**ROTAX.****TECHNICAL BULLETIN**

No. 912-08

Electronic module with π -Filter ROTAX Engine Series 912 A

- Subject:** Exchange of both SMD electronic modules, part-no. 965 356.
- Engines affected:** All engines of series 912 A, from engine serial-no. 4,076.064 onwards to engine serial-no. 4,380.753, installed in aircraft certified to JAR-VLA or equivalent requirements. In serial production the new type electronic module is installed beginning with engine serial-no. 4,380,754 onwards, and therefore no action is required from that engine serial-no. and higher.

Consult also Illustration 1, 2, 3 and 4 on page 3 and 4.

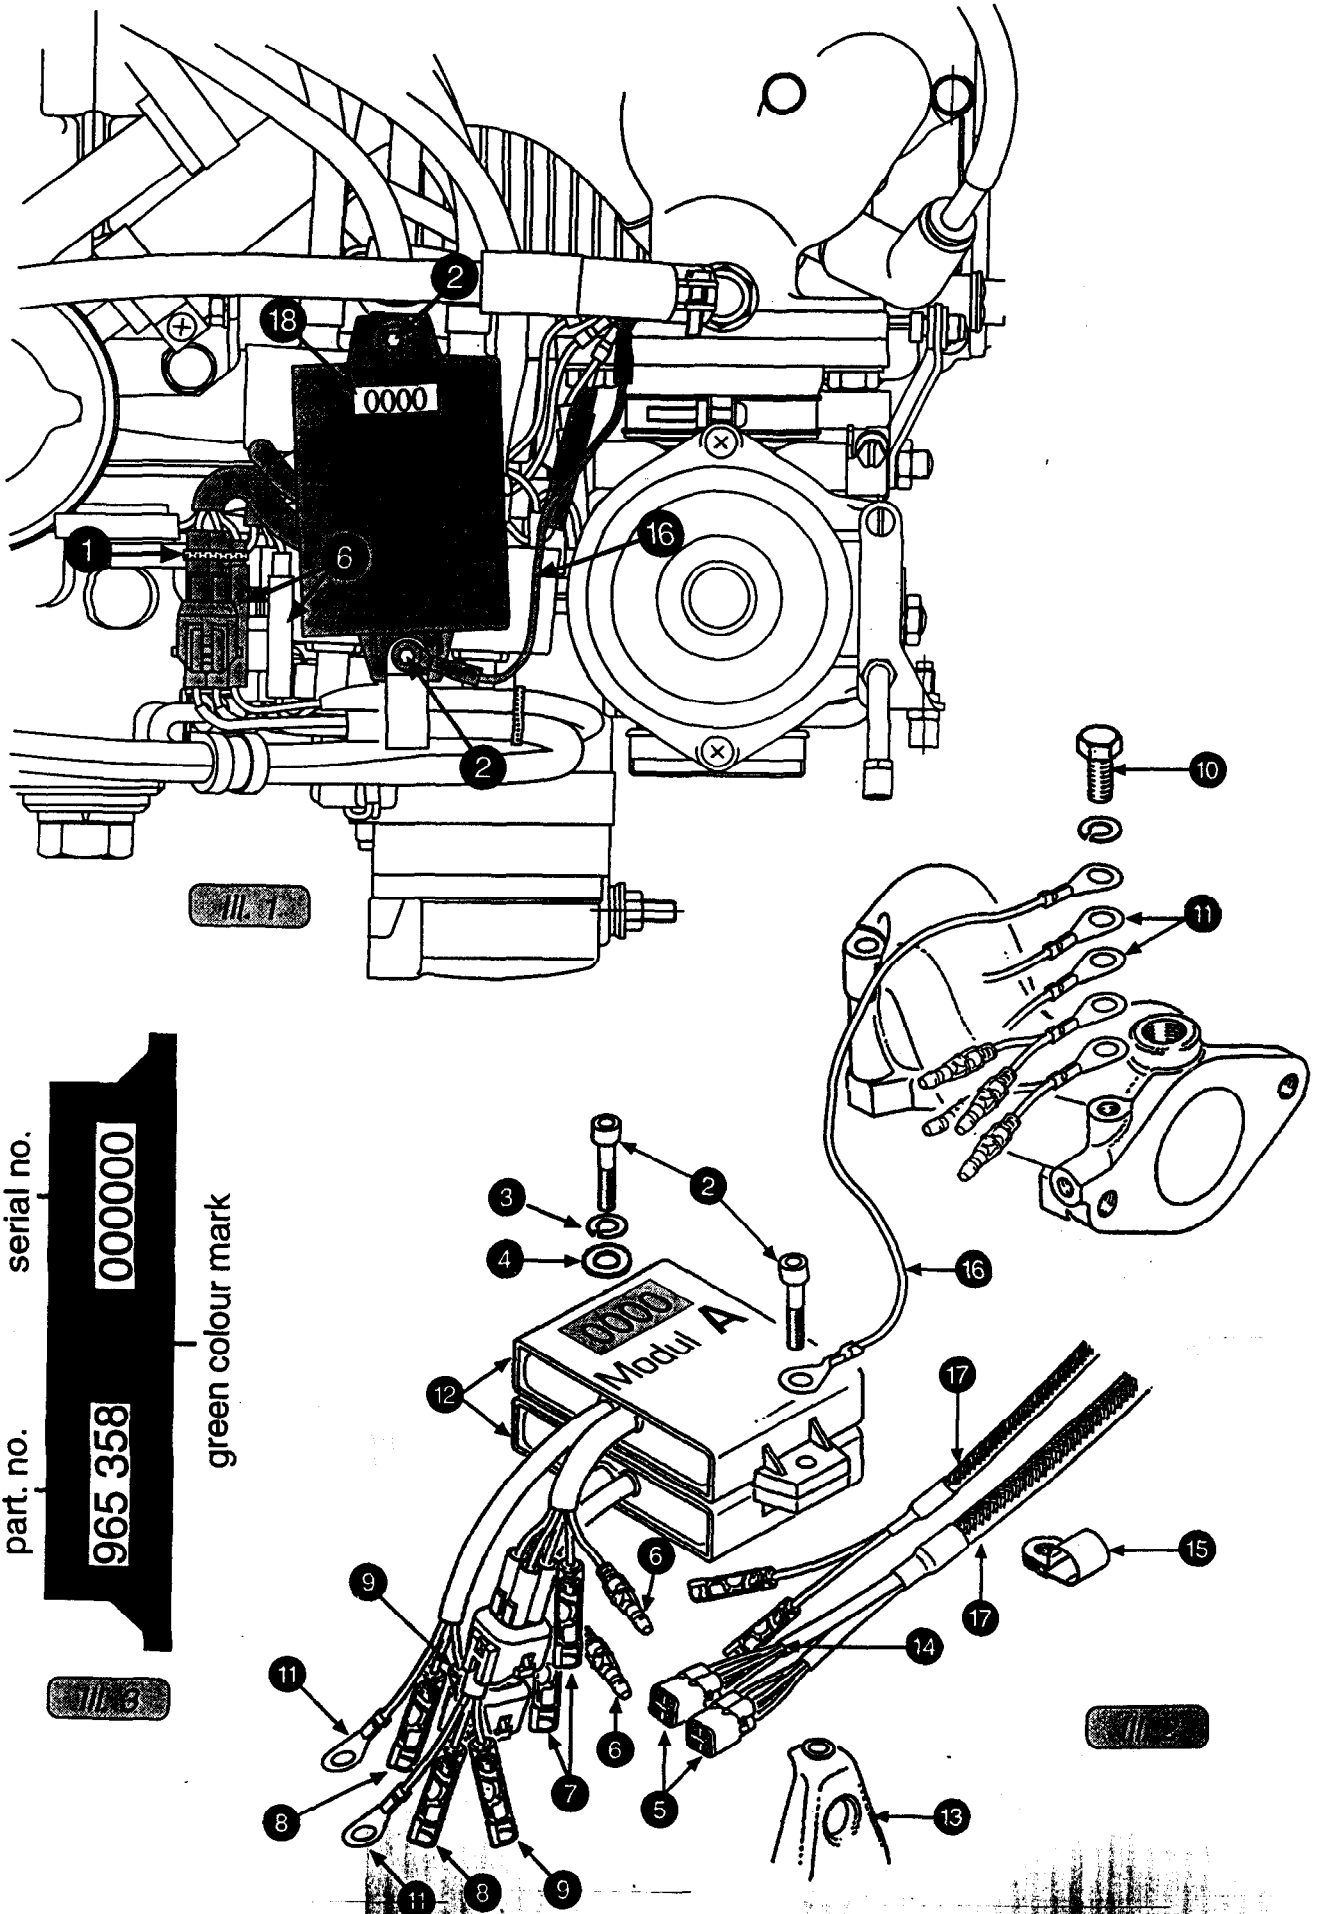
- 1) Disconnect minus terminal of aircraft battery.
- 2) Cut snap tie ① of plug receptacle. Remove both Allen screws ② M5x25 along with lock washer ③ and washer ④. Mark and unplug both 4-pole plug connections ⑤ of pick-up lines, the plug connection of the red charging lines ⑥ and the plug connection of the brown stop lines ⑦. Mark and unplug the plug connections of the yellow ⑧ and white line ⑨, of the threefold cable cord leading to the ignition coils. By removing hex. hd. screw ⑩ detach the grounding cables ⑪ (one each per electronic module). Both electronic modules can be taken off now.
- 3) Connect the new type of electronic modules part-no. ⑫ . 965 358 in reversed sequence according to the marking or as shown on the wiring diagram (Ill. 4) and place the two electronic modules back to back on ignition coil bracket ⑬.

◆ **NOTE:** The two modules are identical and are marked on the front side with a serial and part number. The 4-pole plug for ignition circuit "A", marked blue and red on end of insulation hose shall be connected to the top module.

Attach electronic modules along with both cable assemblies, cable clamps ⑮ and grounding cable ⑯ with Allen screw ② M5x25. Attachment on the other side by Allen screw ② M5x25 and lock washer ③ and washer ④.

■ **ATTENTION:** The metal braid ⑰ over the two cable assemblies has to rest completely in the cable clamp ⑮.

For traction relief secure again both 4-pole plugs with snap tie ①. Attach all 5 grounding cables with the hex.hd. screw ⑱ M6x16 and lock washer on intake manifold.

Wiring diagram
ROTAX 912 A
with electronic module
965 358 (π -Filter)

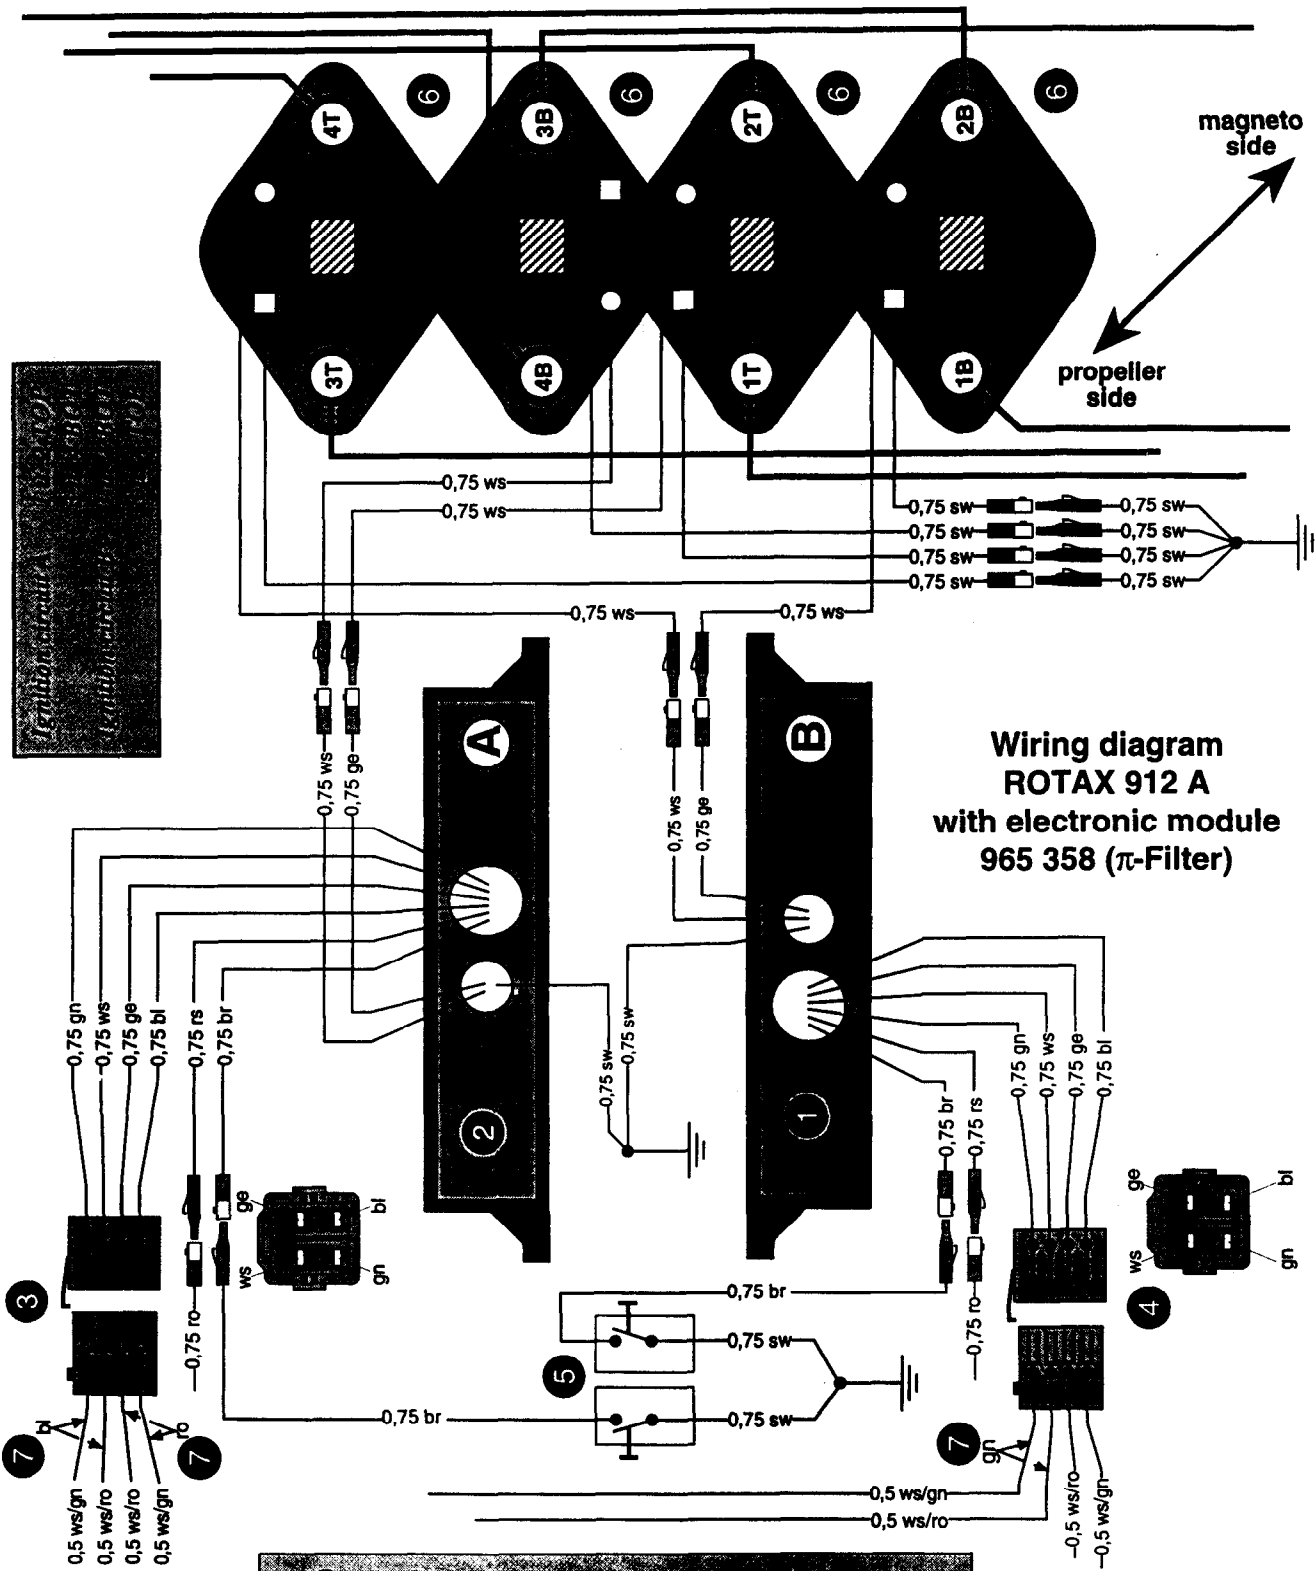
The complete ignition unit is company tested and furnished with a serial number ⑰.

◆ **NOTE:** This 4-digit number on top side of electronic module has to be fastened on the new type of electronic module.
